Town of Surfside

RFQ 2022-05

Construction of Town of Surfside 96th Street Park

Addendum No. 4

6 ENLARGED 2ND FL. BATHROOM PLAN
SCALE: 1/2" = 1'-0"
A-4.1

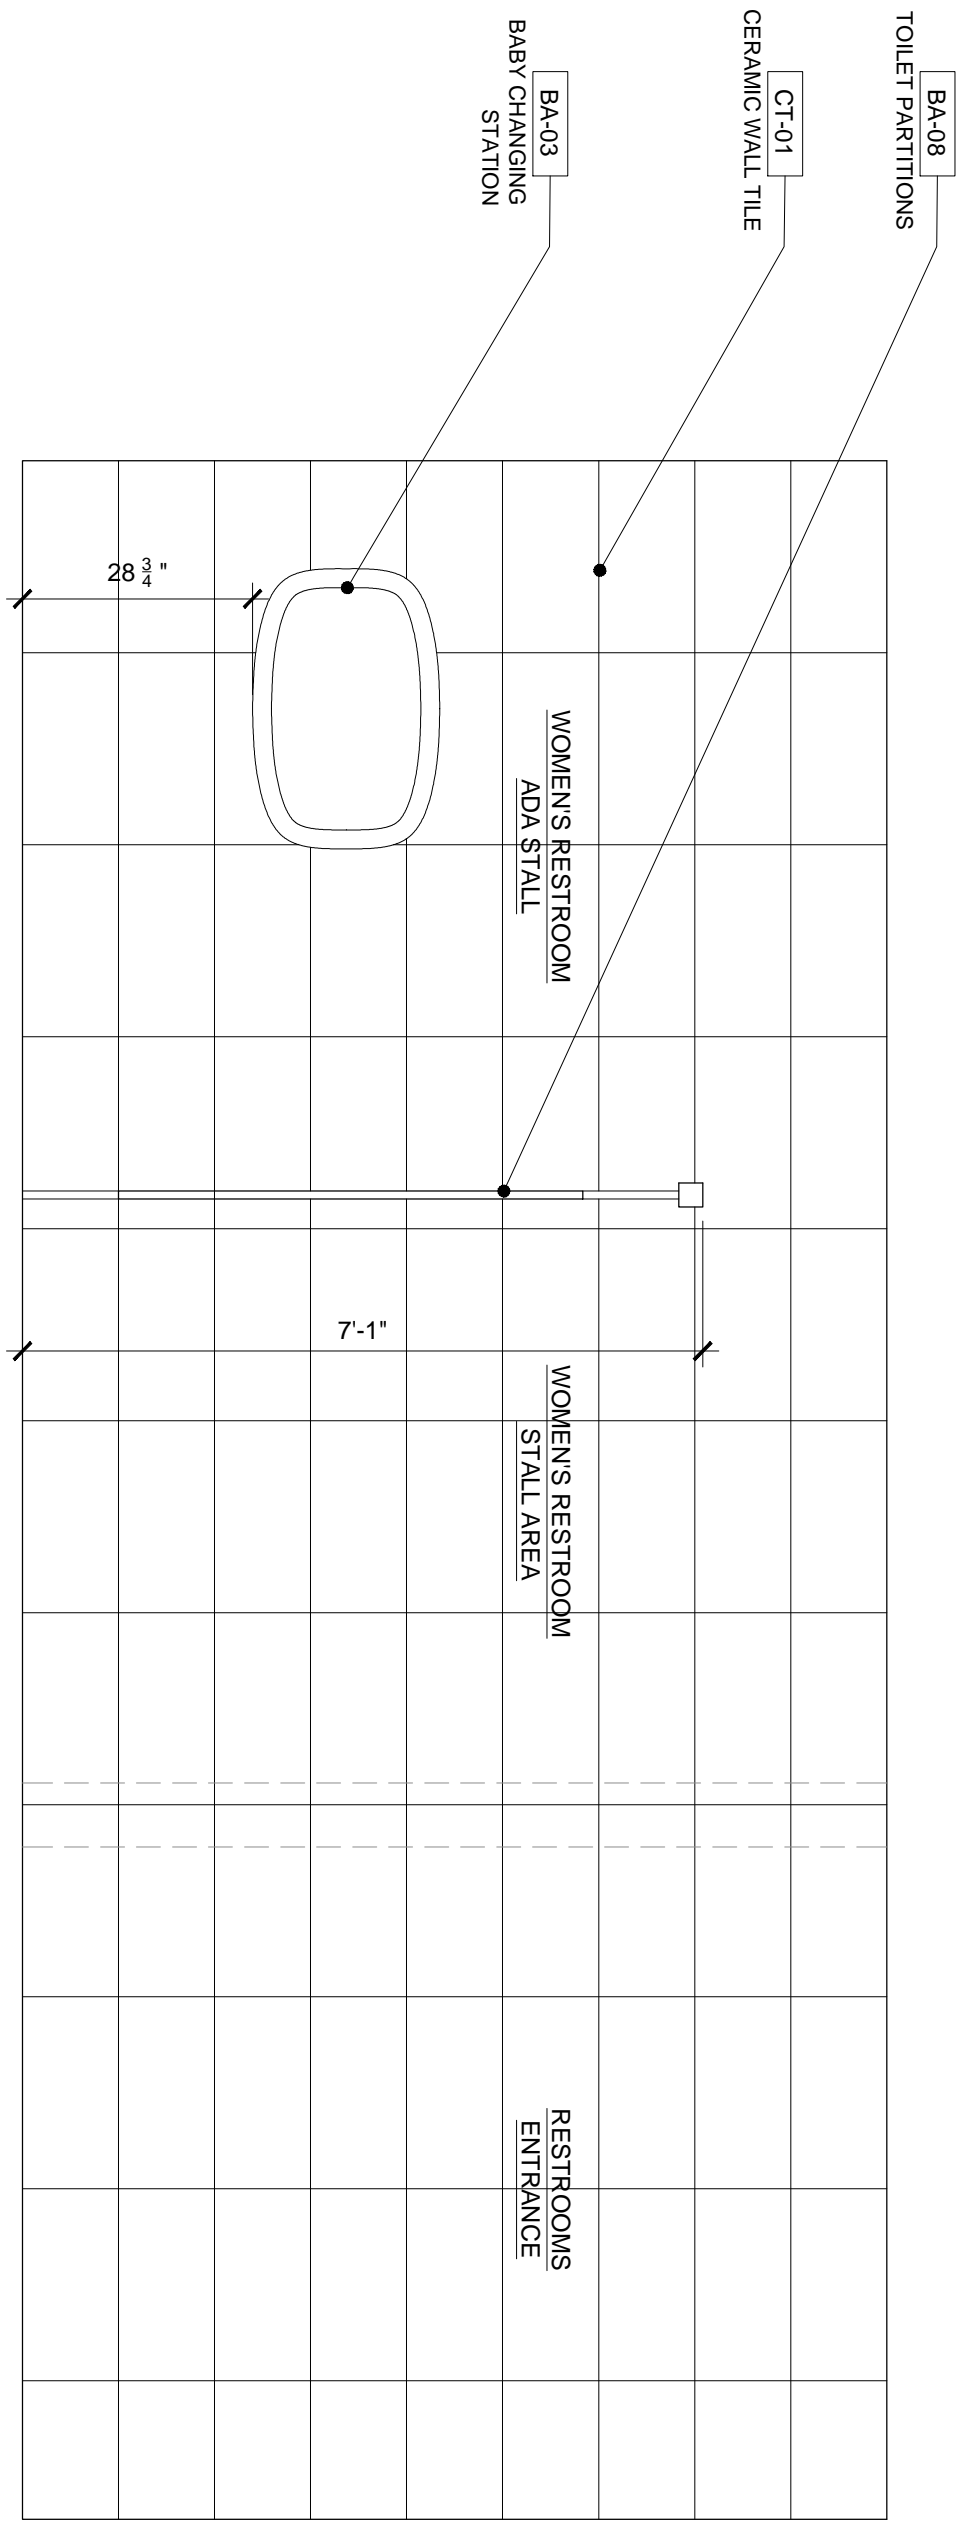
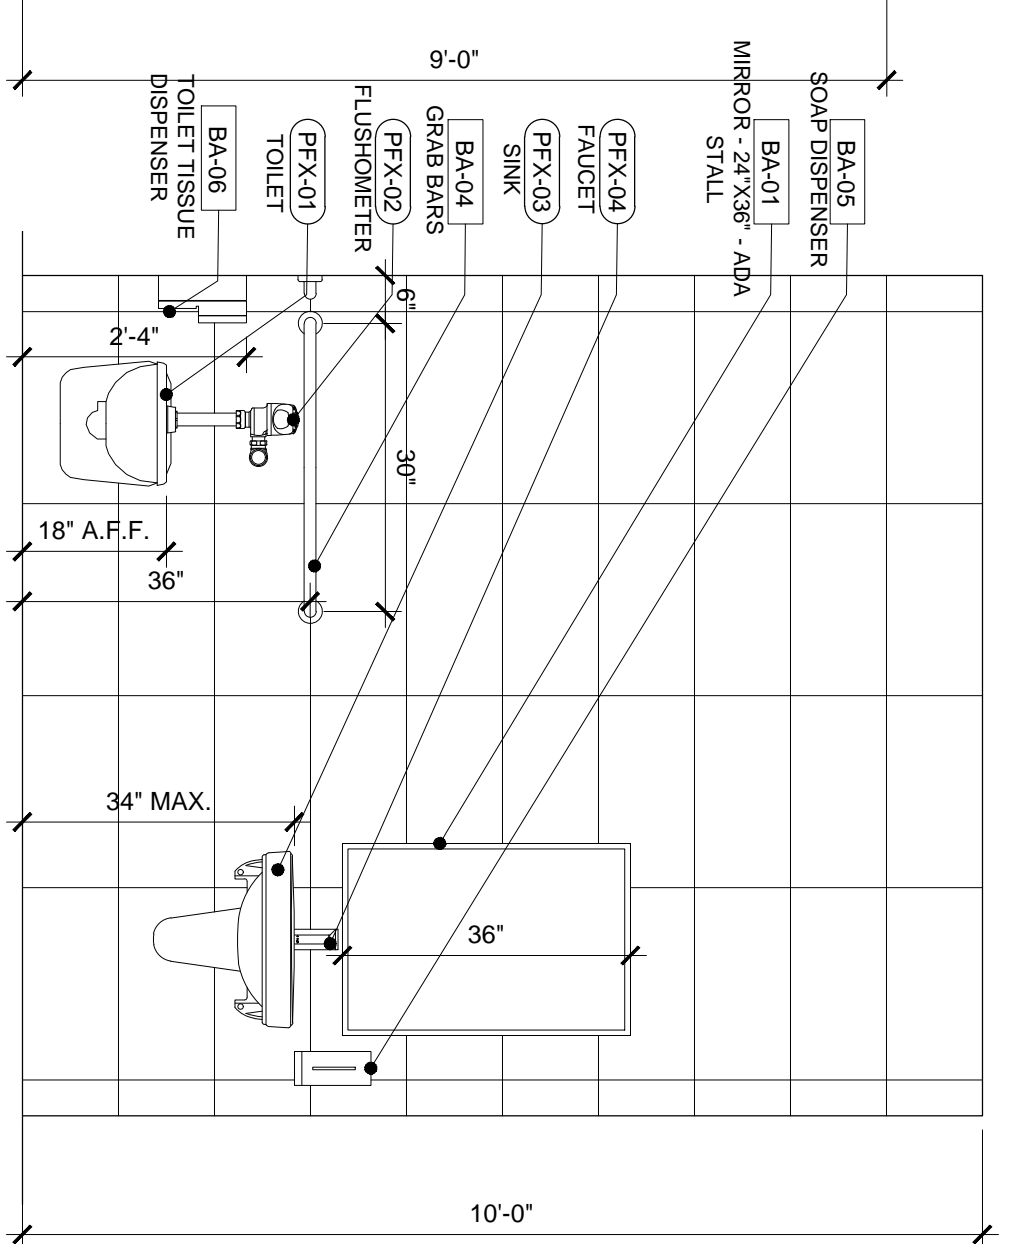
52. Plans do not specify any restroom accessories for the Second Floor Bathroom. Please provide.

See enlarged elevations for 2nd floor bathroom on sheet A-4.1. Provided tags for accessories and fixtures.

1 KITCHEN ELEVATION #1
A-4.3 SCALE: 1/2" = 1'-0"

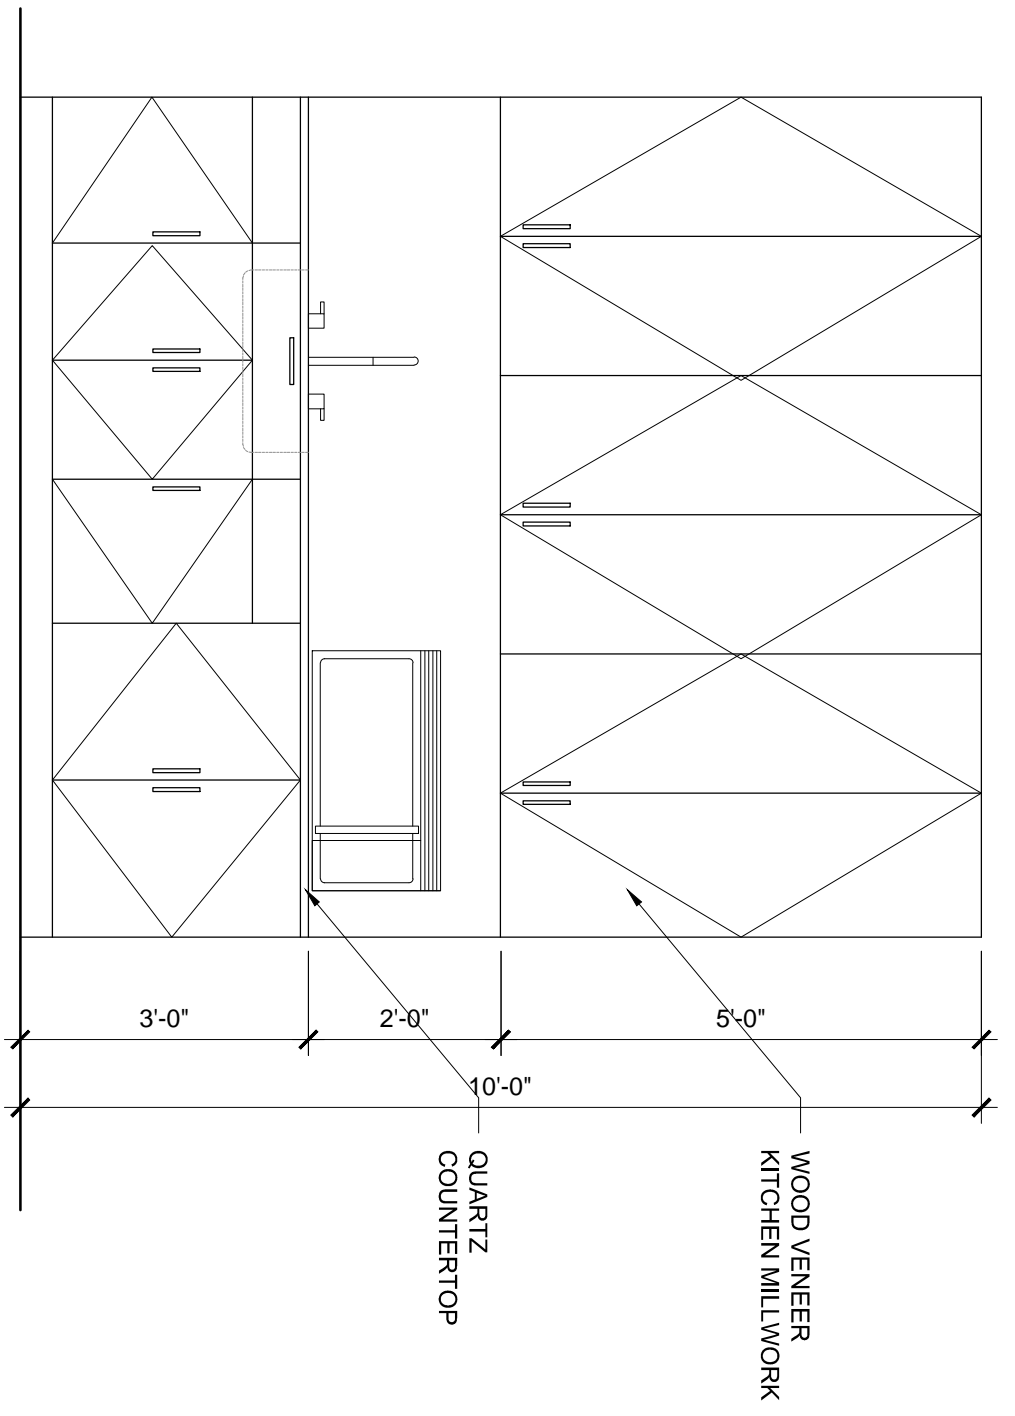
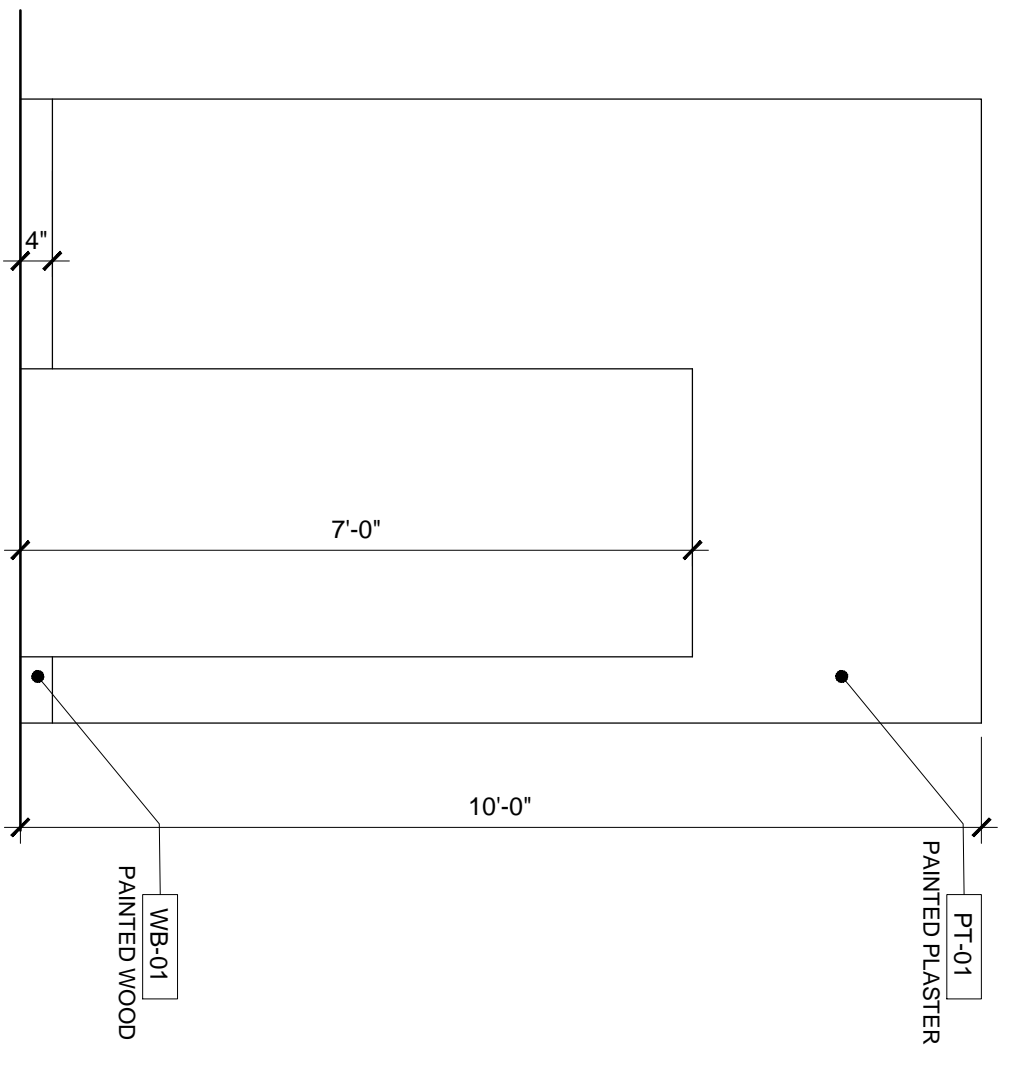
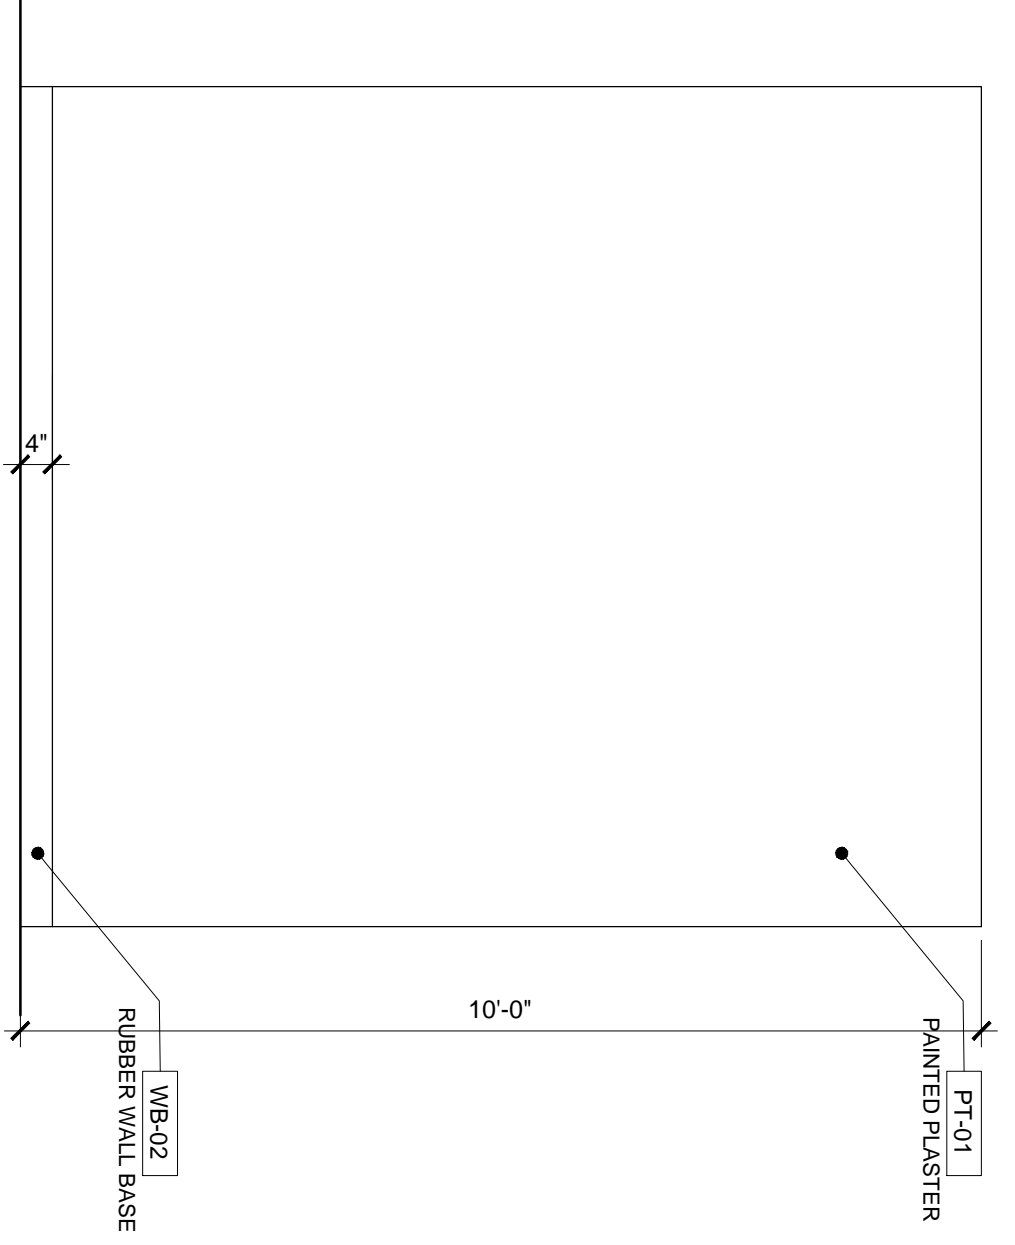
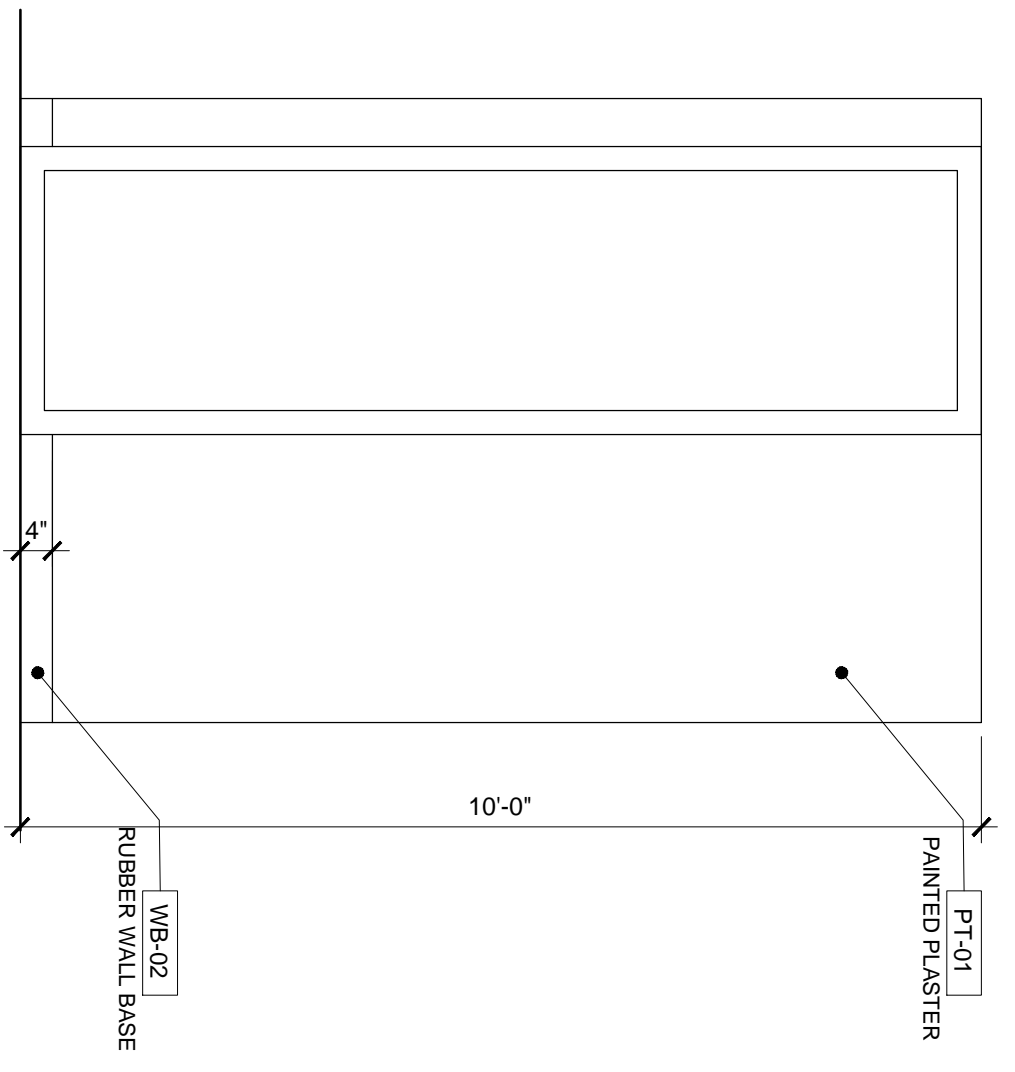
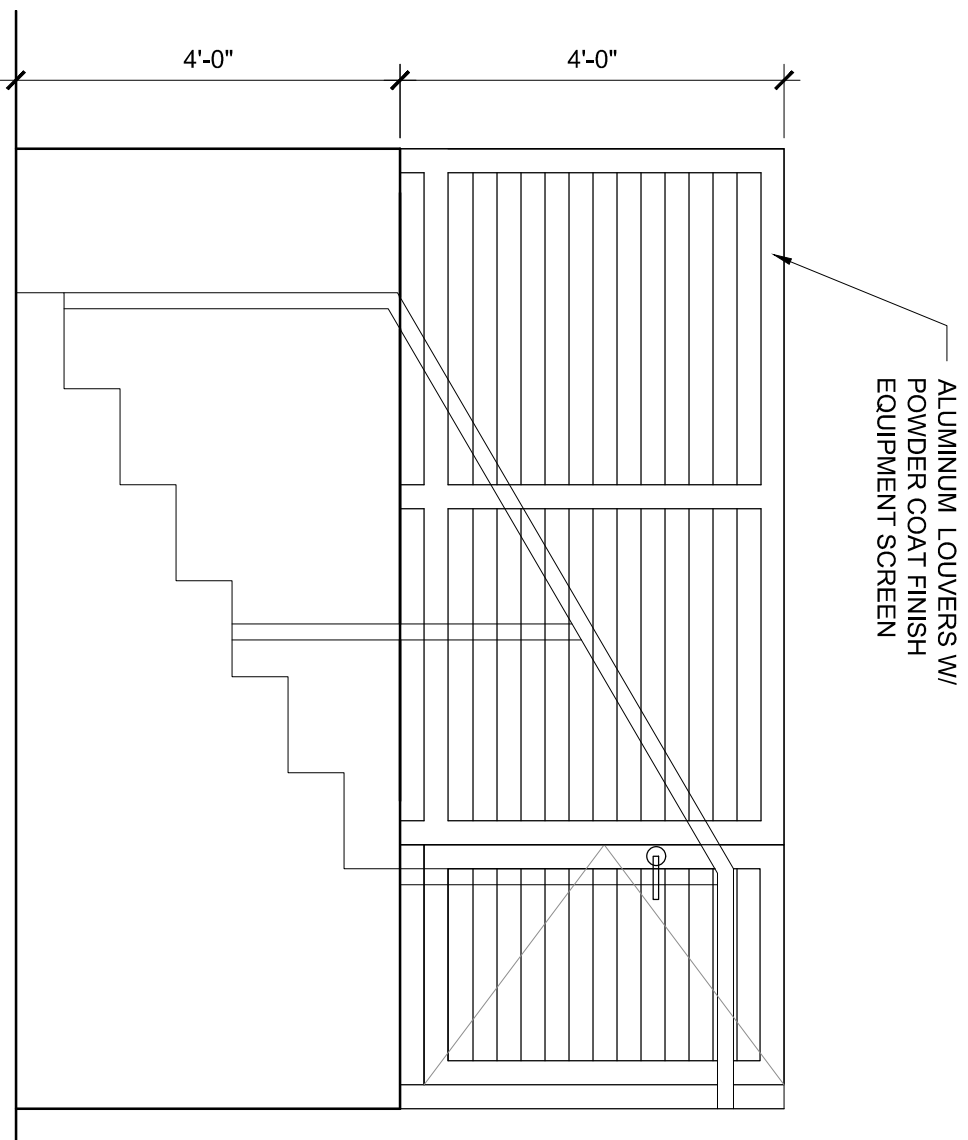
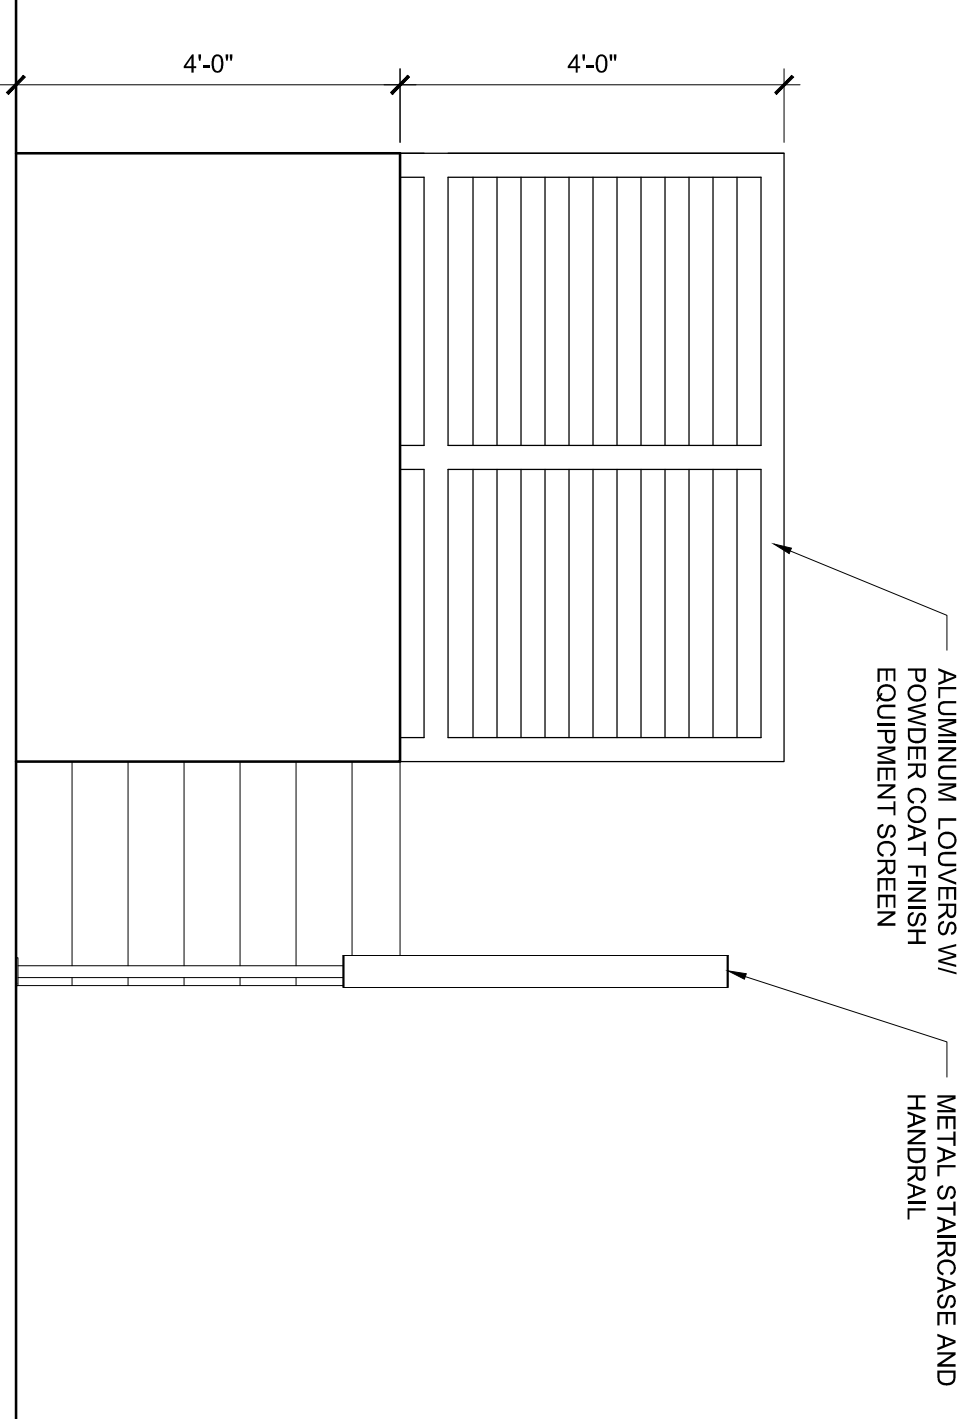
40. The 2nd floor Kitchen is depicting base and wall cabinets. Drawings do not provide any elevations/sections/details. Please clarify.

See kitchen elevations on sheets A-4.3.
